ACRS-1693

MINUTES OF THE
ACRS SUBCOMMITTEE MEETING ON
FLUID DYNAMICS
NOVEMBER 16, 1979
SAN FRANCISCO, CALIFORNIA

MARK I LONG-TERM PROGRAM STATUS - MR. GRIMES, NRC STAFF

EFFECT OF STRUCTURAL OSCILLATION
ON LIVERMORE 3D/2D UPLOAD RATIO

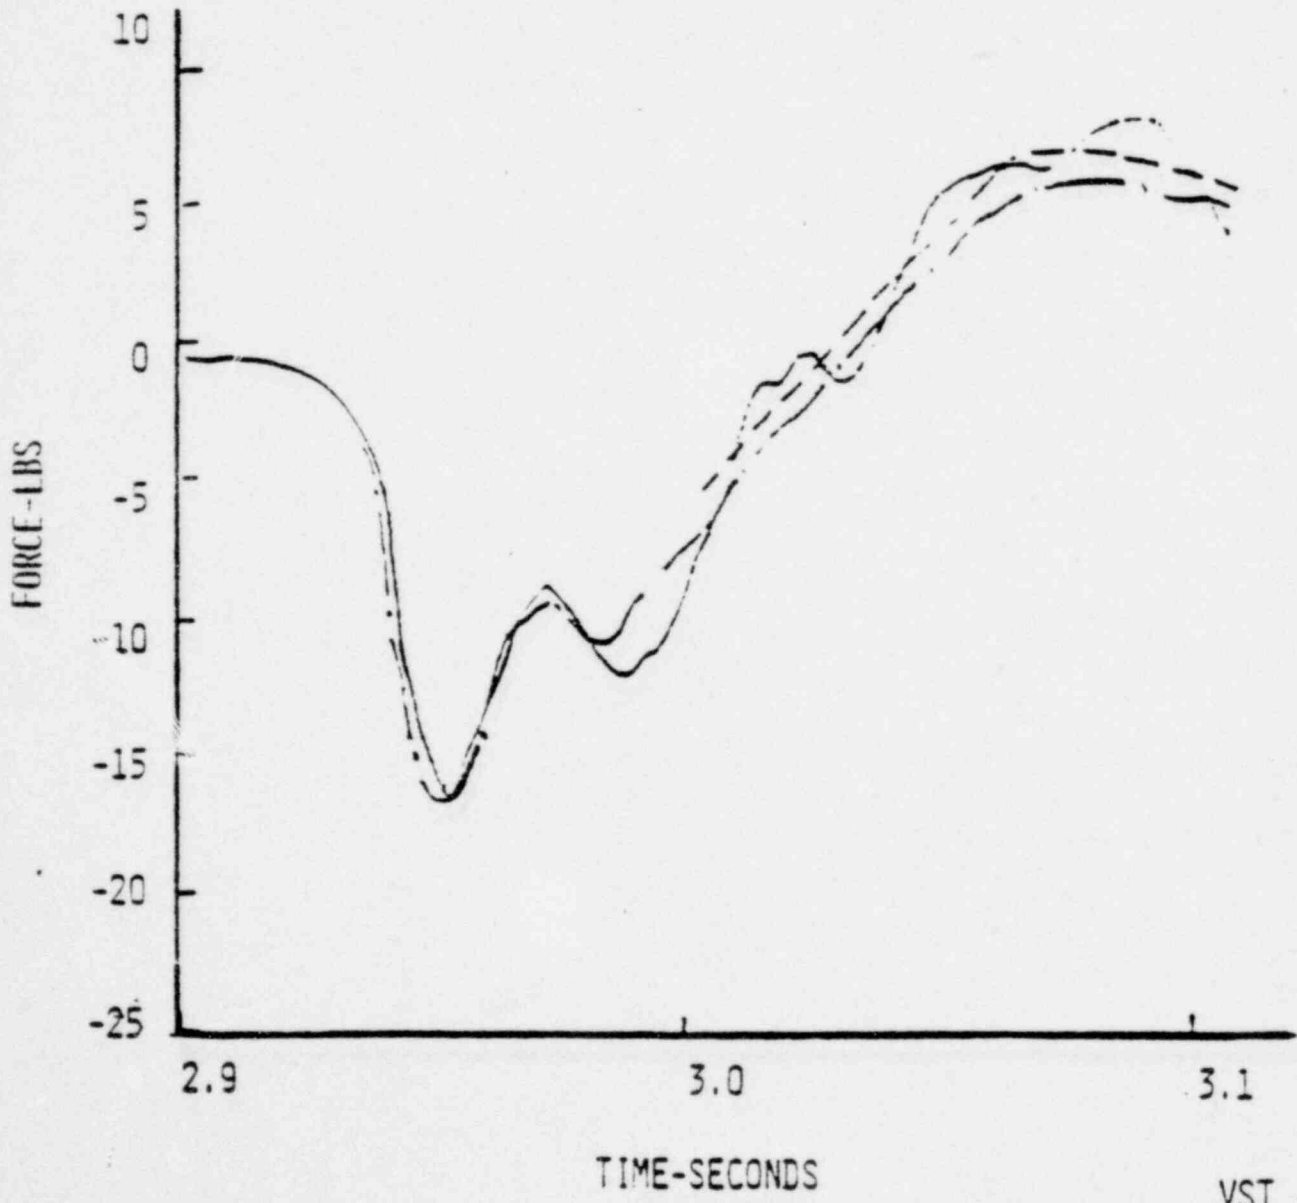
1. Structural oscillations of the 3-Dimensional test facility (Attachment D, page 2).
2. Non-Simultaneous vent clearing between the 2-Dimensional and 3-Dimensional test facilities due to variations in the initial conditions.
3. Interaction between the 2-Dimensional and 3-Dimensional test facilities (Attachment D, page 3).
4. Capacitance and FL/D (flow resistance) differences between the 2-Dimensional and 3-Dimensional test facilities due to the variation in the location of the orifices.

Mr. Tashjian pointed out that, if the above factors are taken into account, he believes that the LLL 3-Dimensional and 2-Dimensional peak uploads would be essentially equal.

DOWNCOMER TYPES

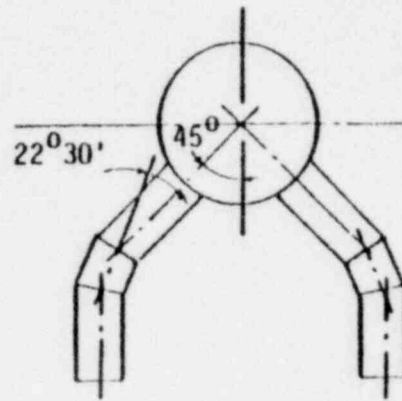
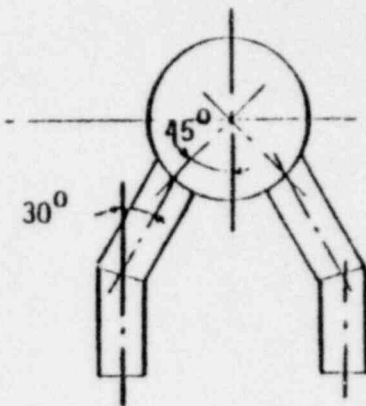
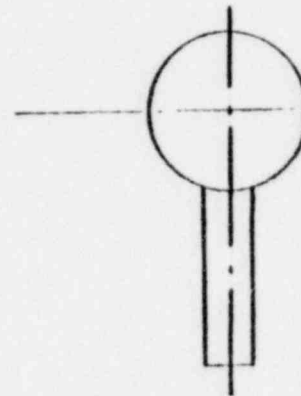
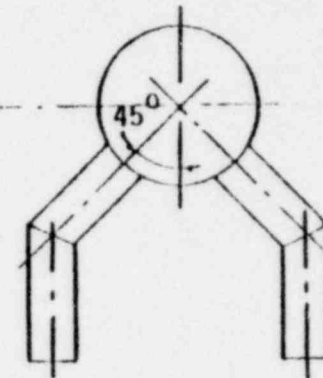
1. EPRI 1/12 Scale 3-Dimensional Test Facility represents the Browns Ferry Plant configuration; the NRC Staff believes that Browns Ferry geometry is not prototypical of Mark I Plants; the 45° downcomer configuration causes an early bubble breakthrough; such an early breakthrough phenomena attenuates the torus uploads because the wet well airspace is not compressed sufficiently. This early bubble breakthrough did not occur in any of the other plant configurations. (For different plant configurations, see Attachment D, page 4).

Measured and Calculated QSTF Vent Deflector Loads, Case 1

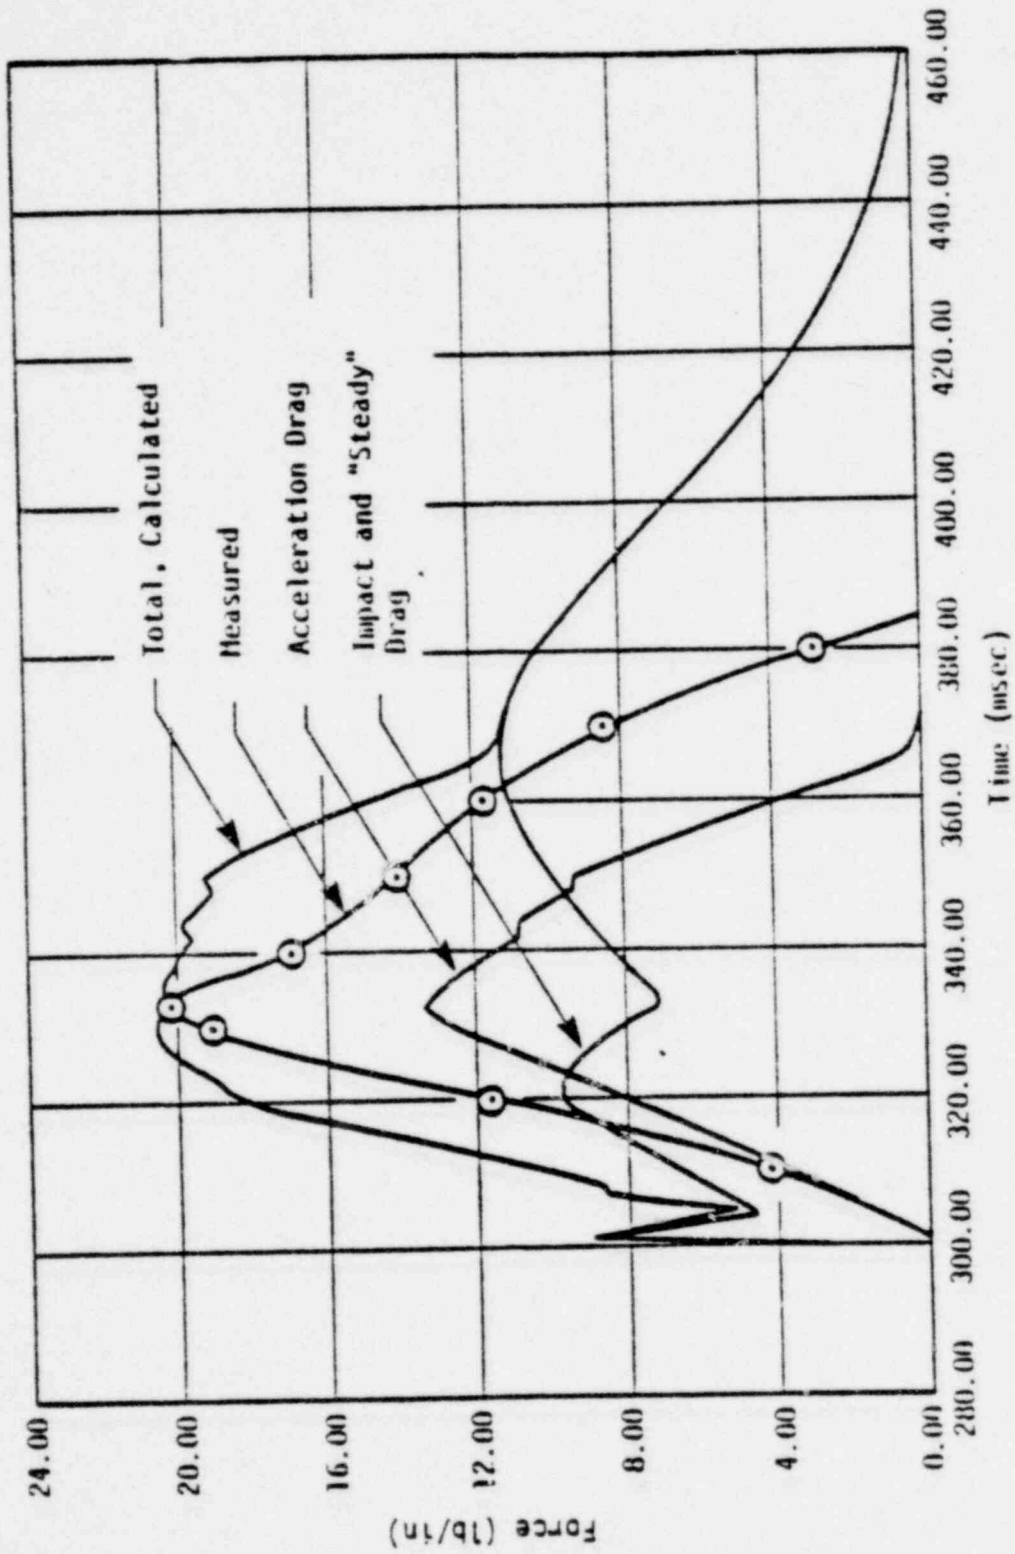
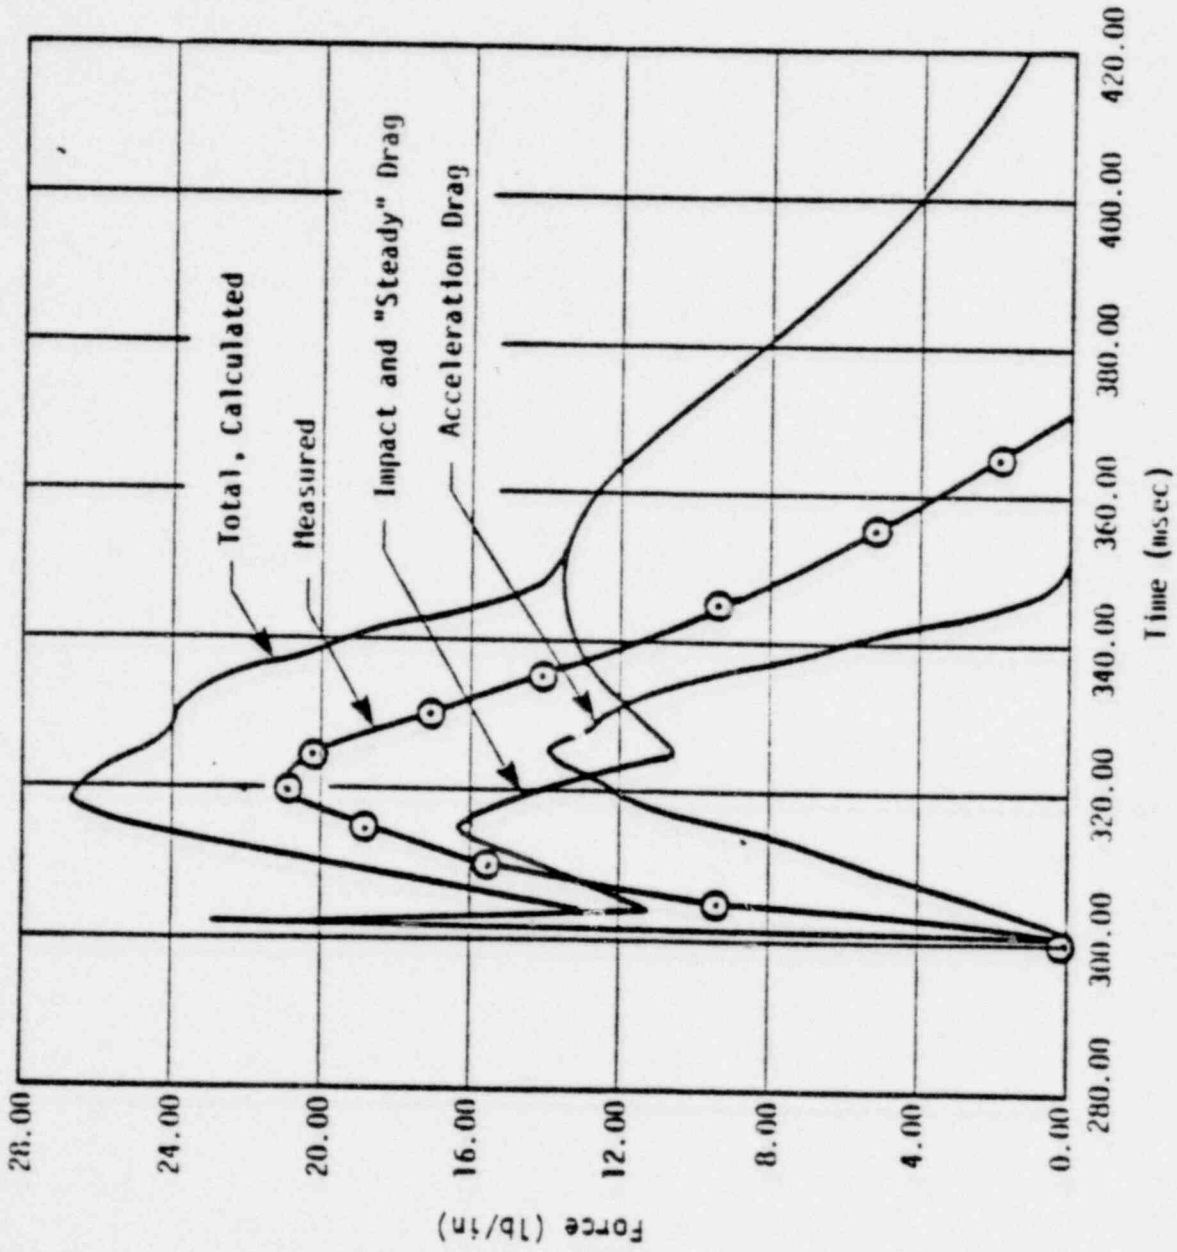
page 4. The instantaneous pool velocity necessary to evaluate the empirical expression is obtained from the QSTF test movie data. The results of the comparison of the QSTF test data and the calculated data (Attachment F, pages 5-7) show that the calculated data is conservative and bounds the measured data. He stated that the comparison of QSTF test data and analytical data obtained with different deflector types and locations indicate that the analytical data over-predicts the deflector load about 33% (Attachment F, page 8).

Mr. Kennedy pointed out that the NRC Staff has some concerns about the methodology used by the Mark I Owners Group in predicting the vent header deflector loads. The NRC Staff believes that the Mark I Owners Group has over-predicted the pool velocity component, but under-estimated the drag coefficient; they expressed concern that this mis-match may produce some non-conservative vent header deflector loads. As a result, the NRC Staff has developed some drag coefficients and suggested that the Mark I Owners Group should use those in calculating the vent header deflector loads. Consequently, the Mark I Owners Group calculated the vent header deflector loads by applying the drag coefficients developed by the NRC Staff along with the pool velocity obtained from the QSTF movie data and observed that the loads were about 20-30% higher than it was predicted earlier; they believe that it is overly conservative and will have significant impact on the structural design.

Mr. Kennedy indicated that as a resolution to NRC Staff's concerns on this issue, the Mark I Owners Group intends to redefine the pool velocity component; they are in the process of doing this and the results will be discussed with the NRC Staff in the near future.
